## Addendum No. 01

**Project Number:** ITT 3187

**Project Name:** Trafalgar B244 Classroom Renovation

<b>To:</b>	<b>Sheridan College.</b> Oakville Campus 1430 Trafalgar Road Oakville, ON L6H 2L1	<b>Project Name:</b>	<b>Sheridan Trafalgar Campus – B244 Classroom Renovation</b> 1430 Trafalgar Road Oakville, ON
<b>Attn:</b>	Nicole Whiteside	<b>Project No.</b>	24-168
<b>Date:</b>	November 26, 2024	<b>ADD. No.</b>	ADDM01
<b>Prepared By:</b>	Giovanni Gatto, B.Eng.

**1 SECOND FLOOR PLAN - HVAC DEMOLITION**  
M-2.1

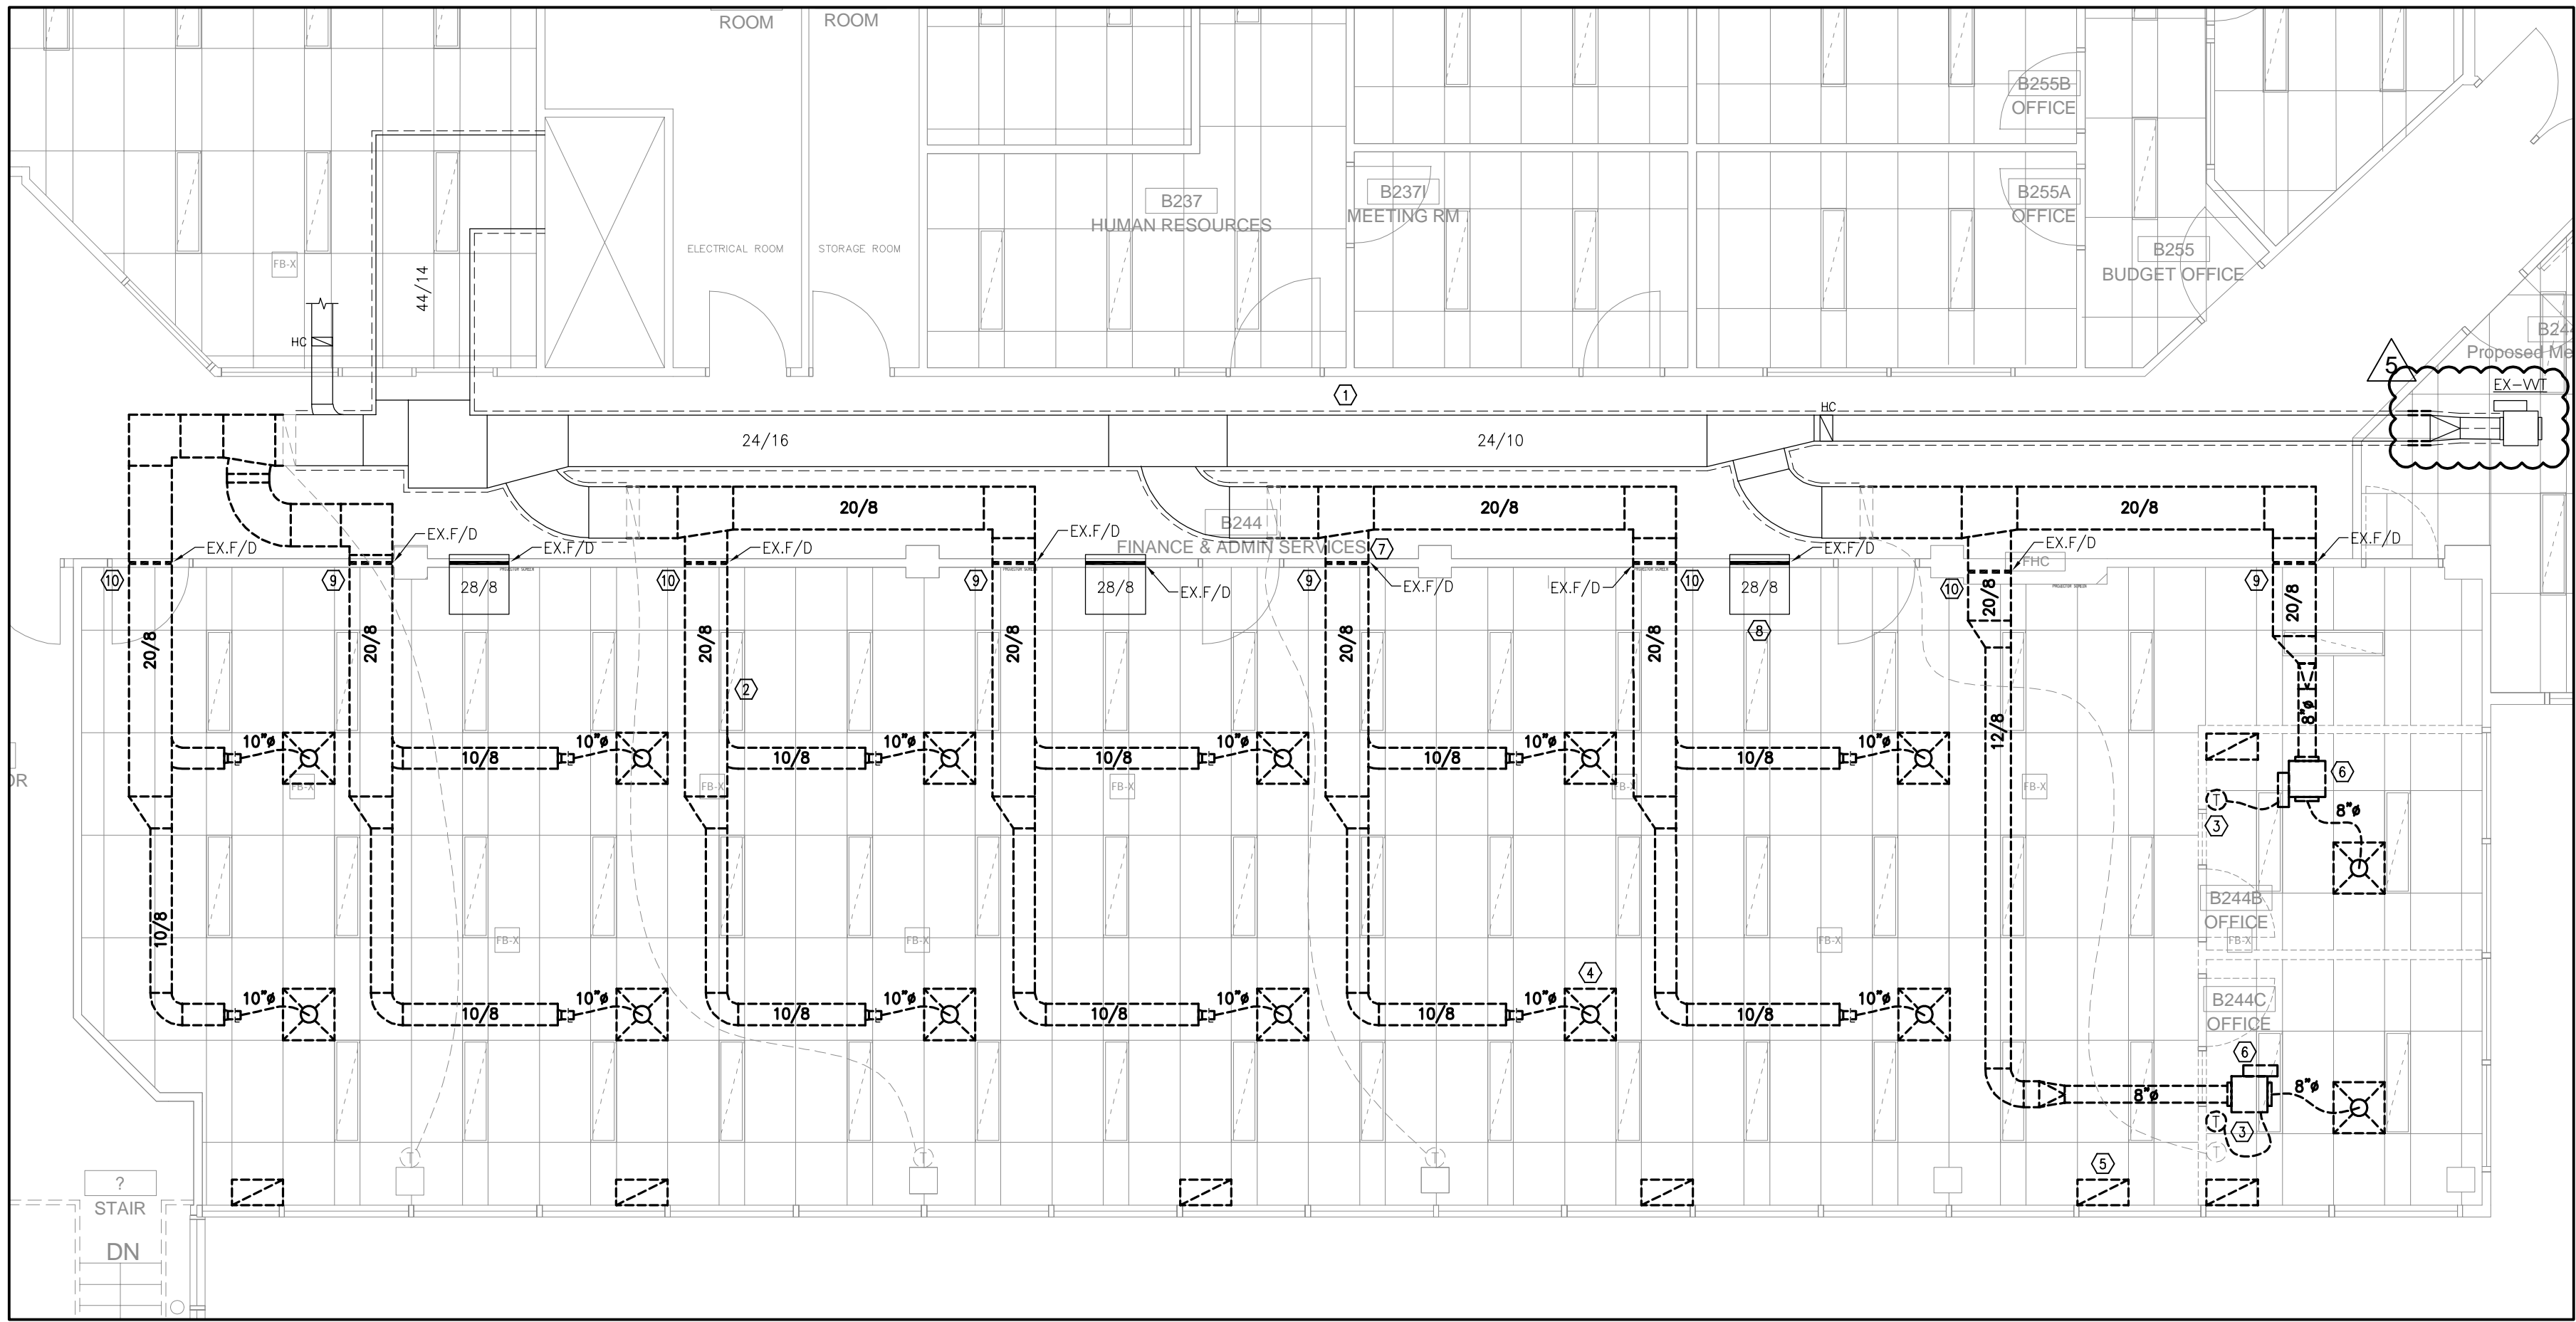
1. Drawing M-1.4
  1. Revision to sequence of operations for heating airflow setpoint in both occupied and unoccupied modes.
2. Drawing M-1.5
  1. Revision to specification of all VAVs to be the same. Various values in the VAV Terminal Unit Schedule has been changed.
3. Drawing M-2.1
  1. Ductwork and VVT box serving adjacent office space is now shown.
4. Drawing M-2.2
  1. Revision to branch ductwork serving each VAV box.
  2. Revision to ductwork sizing after VAV-1 and VAV-2.
  3. Addition of balancing dampers upstream of each VAV box and existing VVT office space.
  4. Revision of balancing for each diffuser.

**1 SECOND FLOOR PLAN - HYDRONICS NEW**  
M-2.4

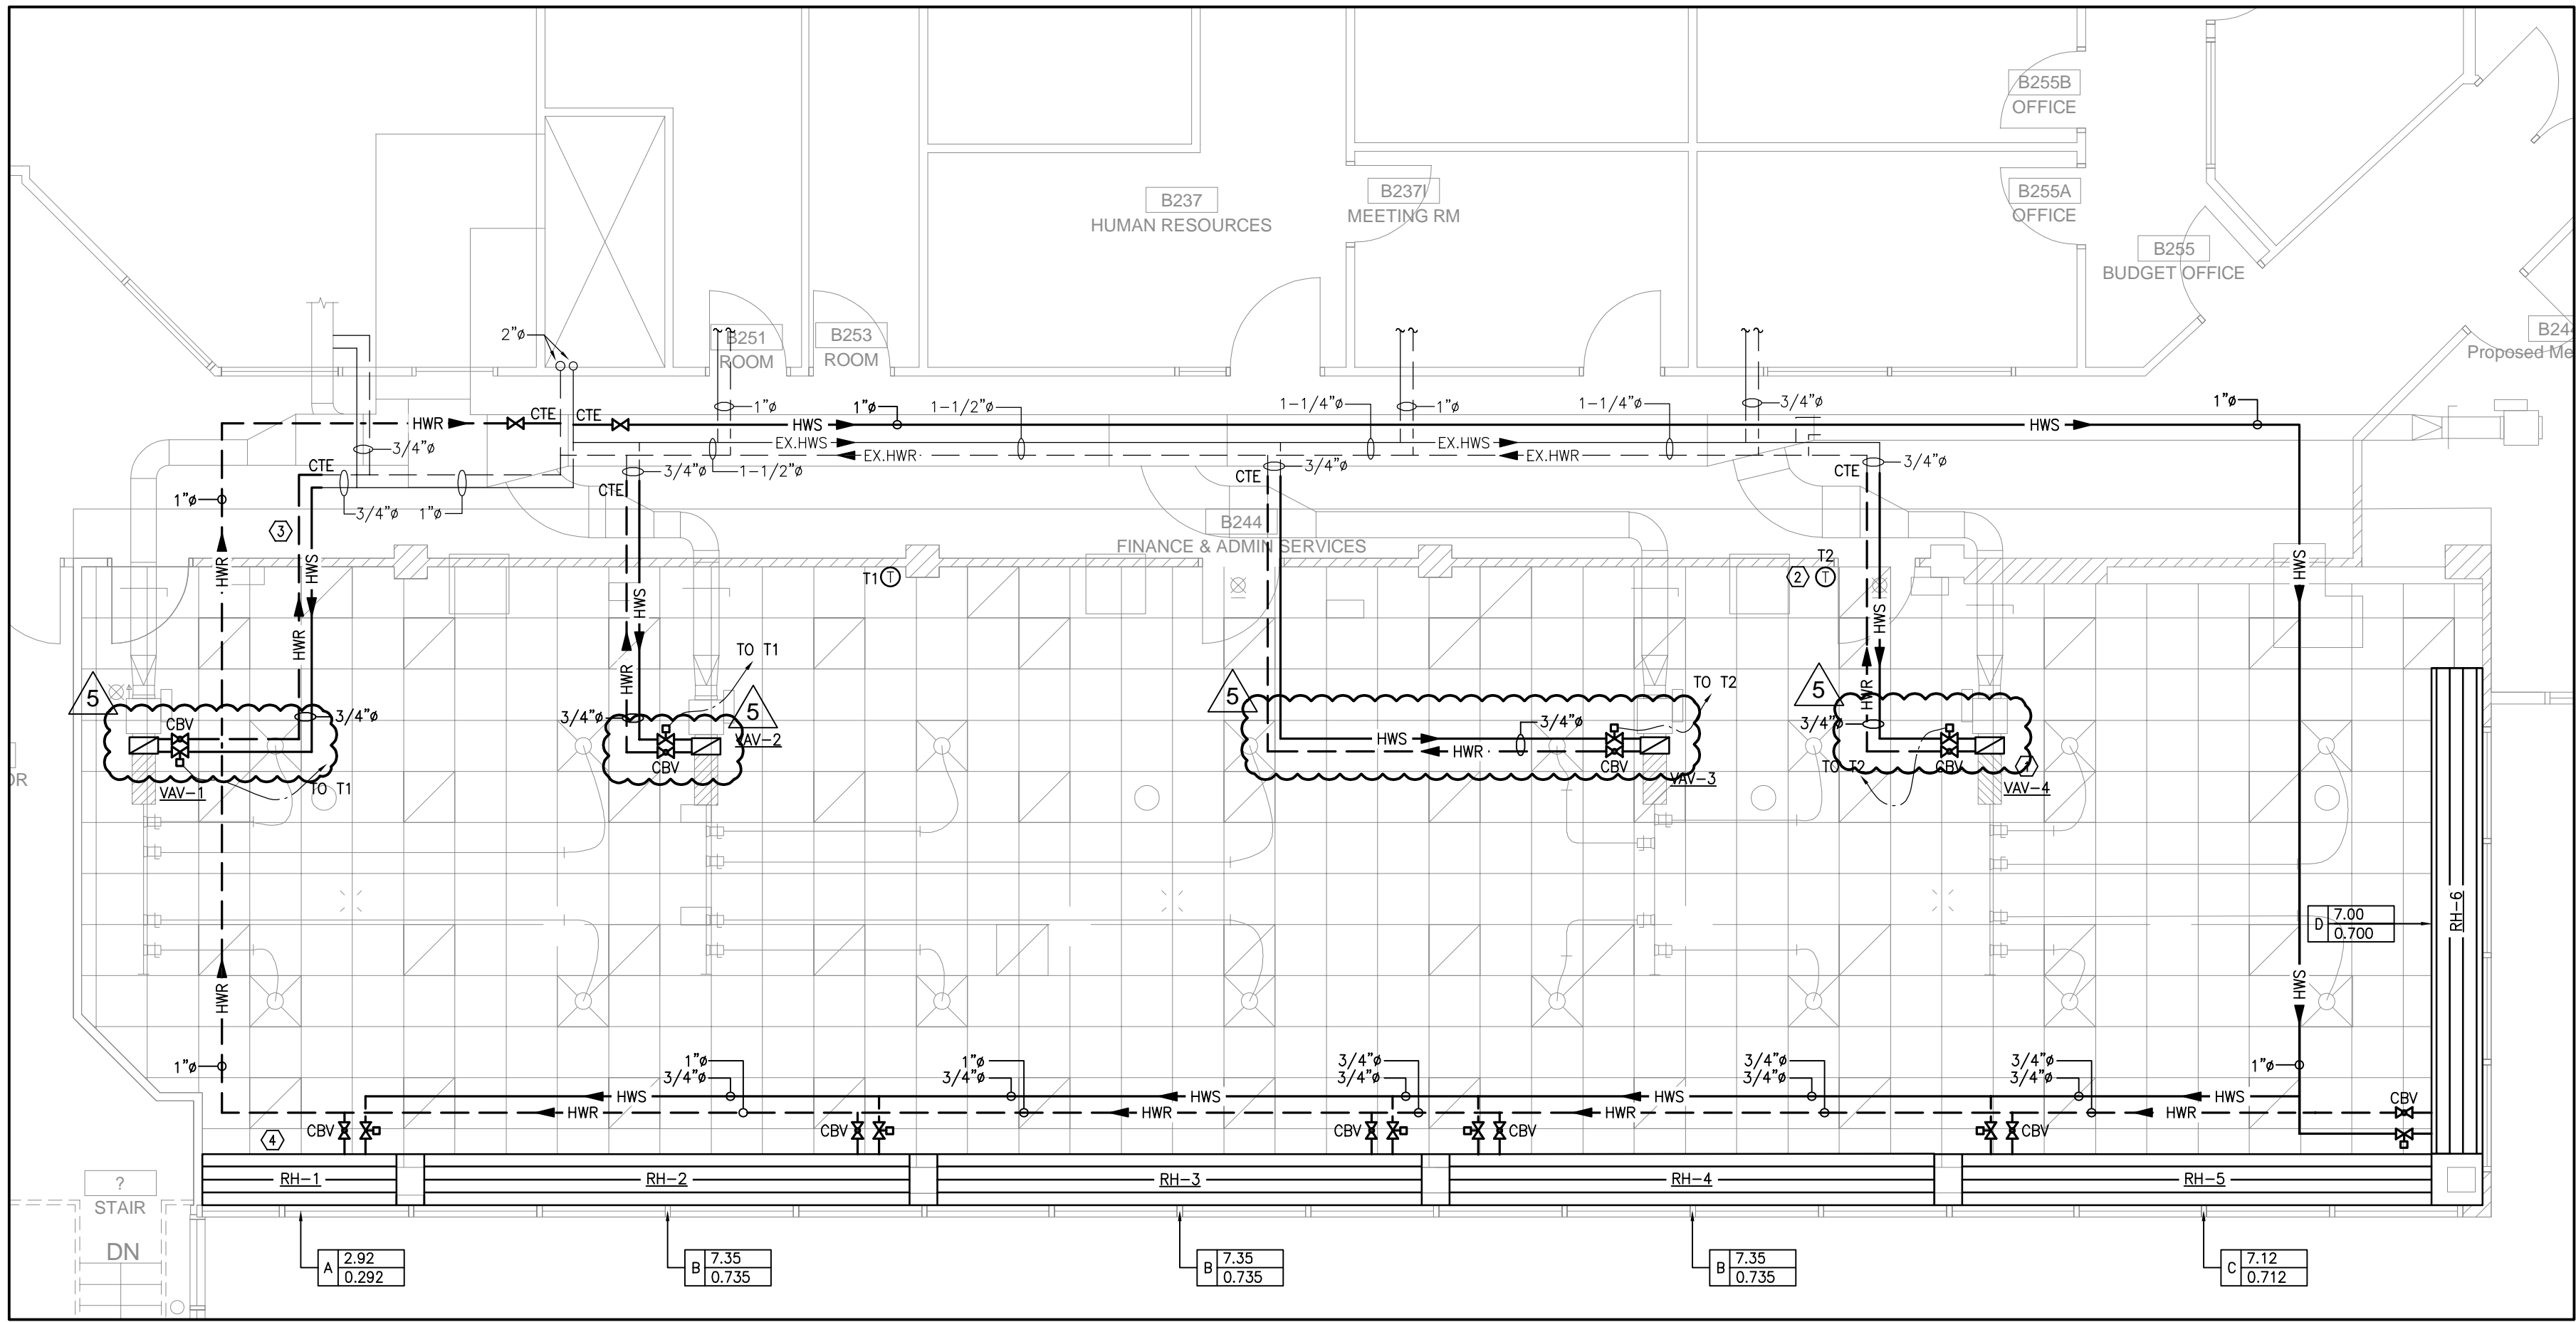
5. Drawing M-2.4

1. Revision of hydronic piping to suit new location of VAV boxes.
